144-Megacycle Transmitter

Part II: Operation and Adjustment

Addenda

Figure 1. Transmitter tank assembly. Note corrected figure of 1/6" center-to-center for the antenna link.

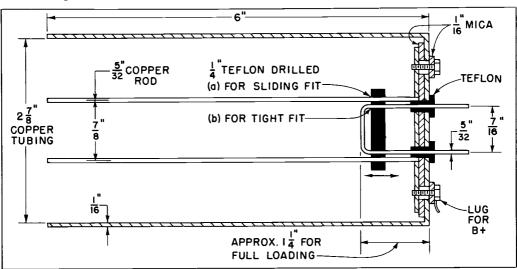
In Part I, the center-to-center measurement for the antenna link (L₁₅) was incorrectly noted as 19/32". The correct dimension is 7/16".

Figure 3. Close-up of the 5894 socket. L₁₉ runs directly from screen pin to feed-through that connects with R₂₁.

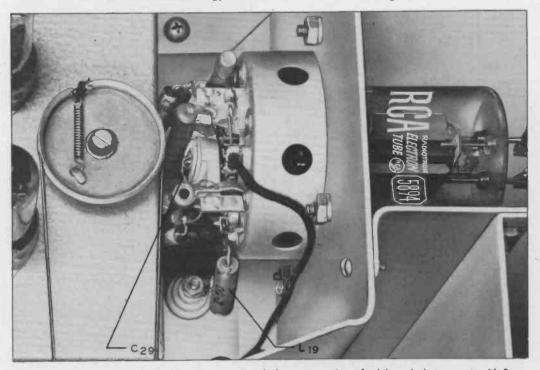
Also in Part I it was noted that R₂₁ served

both as resistor and rf choke. It has been found, however, that the addition of an actual rf choke allows more complete neutralization of the final. (See Figures 2 and 3.)

Figure 2. Original circuit used R_{21} without additional 5894 screen-lead choke, but addition of L_{19} (Ohmite Z-50) allows more complete neutralization of the final.
